**ZONING AMENDMENT,
& SUBDIVISION STAFF REPORT****Date: September 20, 2007****APPLICANT NAME**

Mooreland Subdivision, Resubdivision of Lots 1-3

LOCATION1520 Terrell Road
(Northeast corner of Terrell Road and Dauphin Island Parkway)**CITY COUNCIL
DISTRICT**

Subdivision approval to combine three legal lots of record into one legal lot of record, and Zoning approval from R-1, Single-Family Residential, to B-3, Community Business, to allow automobile sales.

SITE PLAN

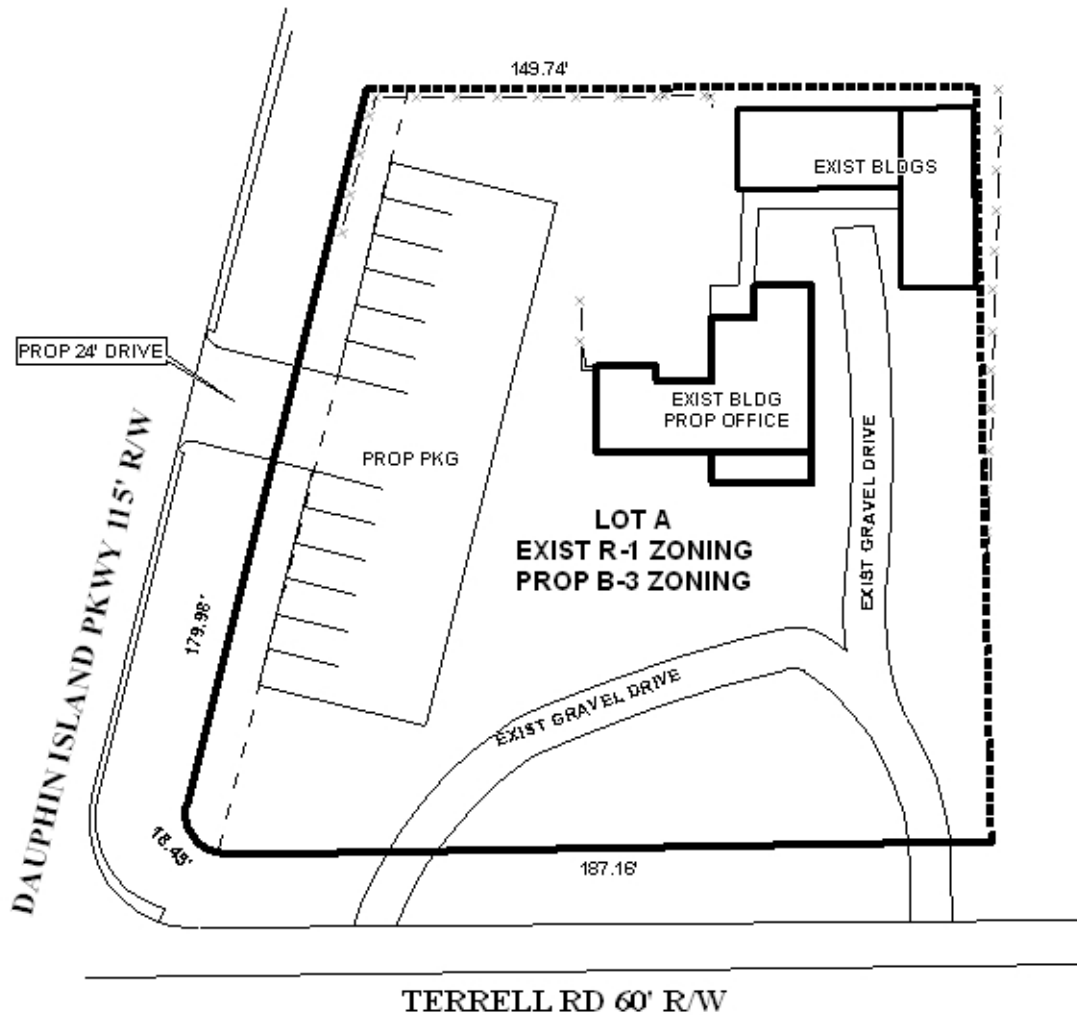
Driveway number, size, location, and design to be approved by Traffic Engineering and conform to AASHTO standards. No dimensions are shown for the radius of the driveway entrance. A minimum radius to twenty feet should be provided.

The site plan depicts the site improved with parking and access to Dauphin Island Parkway, including 12 parking spaces; however, an entry from Terrell Road would have to be eliminated or brought in to compliance of the Zoning Ordinance. The parking calculations are not illustrated on the site plan to provide the required parking for the office and garage. Thus more information is required to determine if twelve parking spaces would be needed for the proposed use. Also, it appears that the surface maneuvering area from Terrell Road do not meet the minimum standards of the Zoning Ordinance.

Regarding the landscaping calculations, it appears that sufficient *area* will be available for landscaping to meet the minimum requirements of the Zoning Ordinance. The site plan does not, however, depict the actual placement of heritage and understory trees required to depict full compliance.

The site plan does not indicate the location of a dumpster or other private waste facility, thus the site plan should be revised to depict the dumpster location. The location, furthermore, should be located away from adjacent residential uses, not only in terms of protecting residences from offensive odors, but also from the noise of the dumpster being emptied during the day or night.

The proximity of a B-3 district next to residential districts will require the provision of buffering, which in this case would likely have to be a 6-foot high wooden privacy fence and 3-foot high solid hedgerow along Terrell Road to screen the parking area from the adjacent residential zoning across Terrell Road. The site plan should reflect the required buffering.

New development normally requires the provision of a sidewalk along the adjacent public right-of-way, therefore a sidewalk should be shown on any future site plans, should the rezoning be approved.

- 1) the submission and approval of a Planned Unit Development (PUD) application;
- 2) the removal of curb cuts to Terrell Road and the installation of necessary landscape materials; and
- 3) full compliance with all other municipal codes and ordinances.

- 1) the placement of a note on the Final Plat limiting the development to one curb cut to each street, with the size, location and design to be approved by Traffic Engineering and in compliance with AASHTO standards; and
- 2) placement of the 25-foot minimum building setback lines on the Final Plat.
